Re: Iowa Avenue Headwall Replacement Request to Execute Change Order No. 2

Change Order No. 02

Differing Site Condition – Saturated and unstable soil beneath proposed apron slab

PLAN OF APRON SLAB AND FOOTING

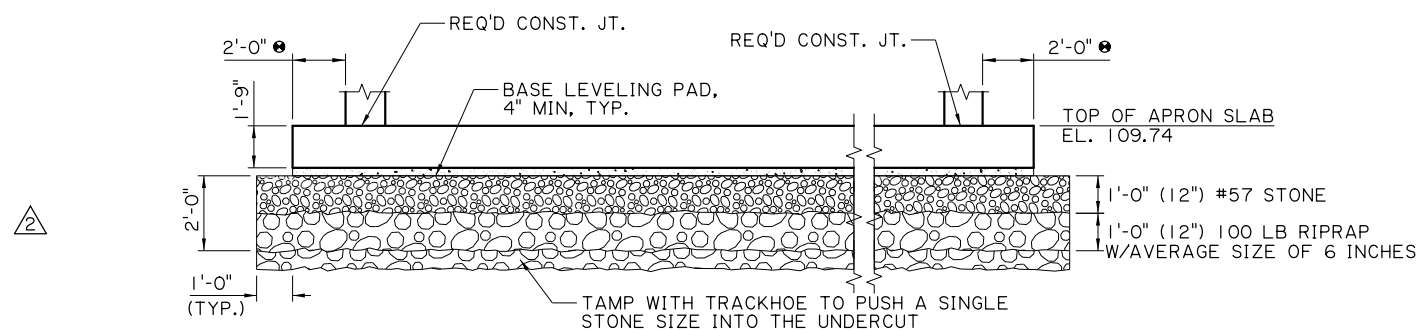
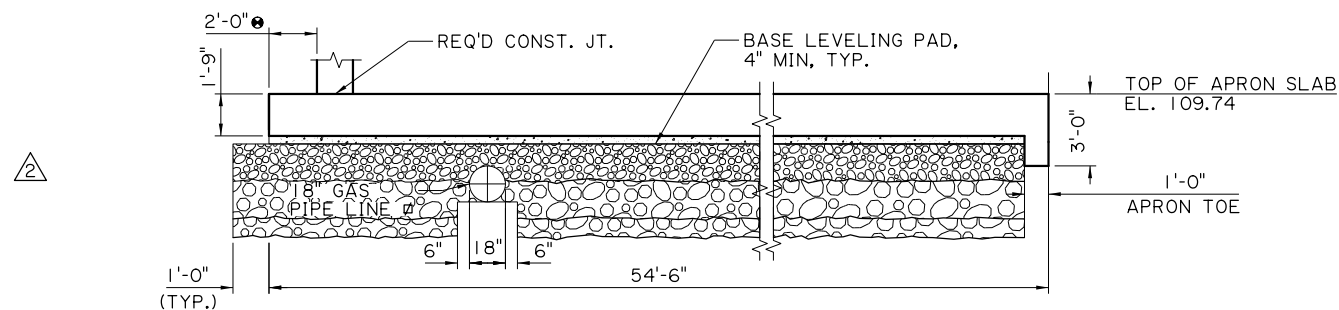
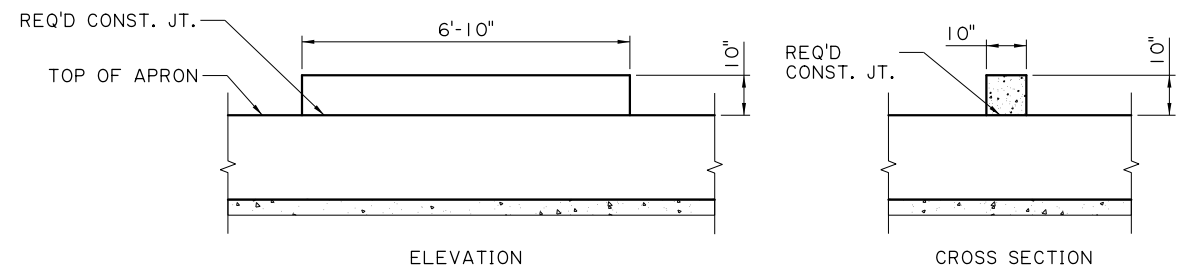
Due to the differing site condition where the soil beneath the proposed apron is saturated with water and therefore, we are unable to achieve proper compaction and adequate subgrade stability for construction of the apron slab, we discussed several options to move forward with Construction.

- In accordance with Maynord's attached CO No. 2, excavate up to 2'-0" below the area of the proposed apron.
- Replace with a foot (12 inches) of 100 lb. riprap with an average size of 6 inches – We recommend that the riprap be dense, durable, and free of clay and shale seams. While we prefer limestone, the specifications allow for use of riprap. Is Maynord going to be using Limestone?

- It is recommended that in lieu of "lightly tamping in place with a trackhoe" that Maynord tamps in the riprap at the bottom of the excavated area with moderate effort in an attempt to push a single stone size (around 6 inches) into the undercut area in order to stiffen up the bottom of the excavation. This could increase the quantity of stone to a minor extent.

- The upper foot (12 inches) will be #57 stone to “lock it in” and also provide a flattened/level surface to install the “leveling Pad” (Mud Slab)
- Once Maynard completes the apron slab installation, riprap is to be installed at the edge of the apron and at the existing and proposed embankment slopes in accordance with Sheet Nos.: 6 & 7 of the contract drawings.

Site Plan

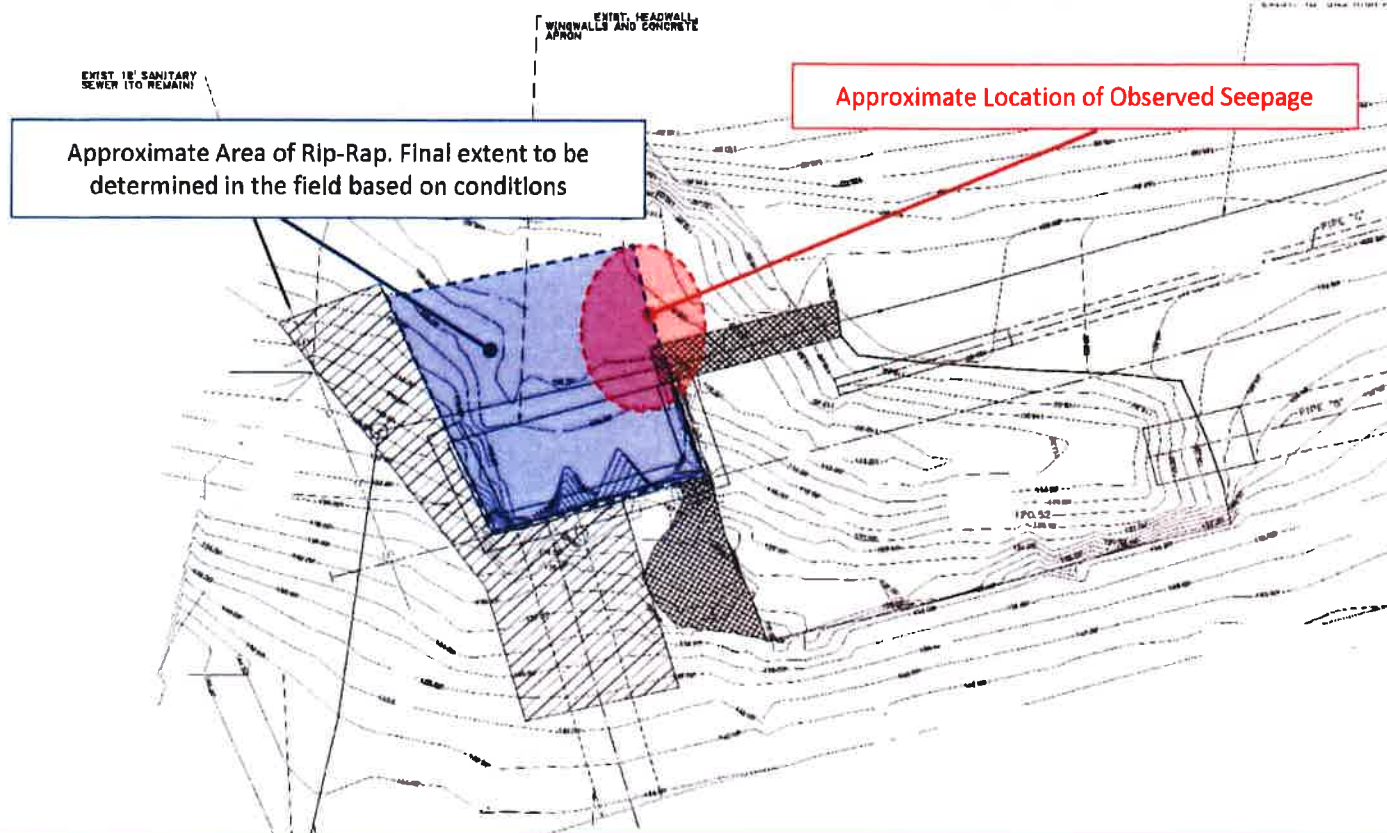
Mr. Barton Schreiner, P.E. of our office visted the site today at the request of Mr. Dudley Maynord. Upon arrival to the site, areas of seepage were observed as illustrated on the attached **Site Plan**. A general observation of the site suggests that the in-situ soils to support the new concrete apron will be susceptible to erosion and scour as illustrated on Photograph No.6 attached. As a result, in order to facilitate construction of the new concrete apron and provide a stable working platform, we suggest the area to underlie the apron (Ref Attached Drawing) be built up to within about 12 inches below finished subgrade (bottom of slab) with large 100# rip-rap. The rip-rap can be an angular limestone or recycled concrete crushed to an equivalent size. The rip-rap once placed can be lightly tamped in place with a trackhoe. The final 12 inches below the apron can consist of No. 57 size crushed limestone or equivalent to better facilitate apron placement. We do not recommend the use of soil backfill in this area due to the potential for erosion and scour that could undermine the new concrete apron. Any on-site concrete rubble that meets the size requirements could be considered for use.
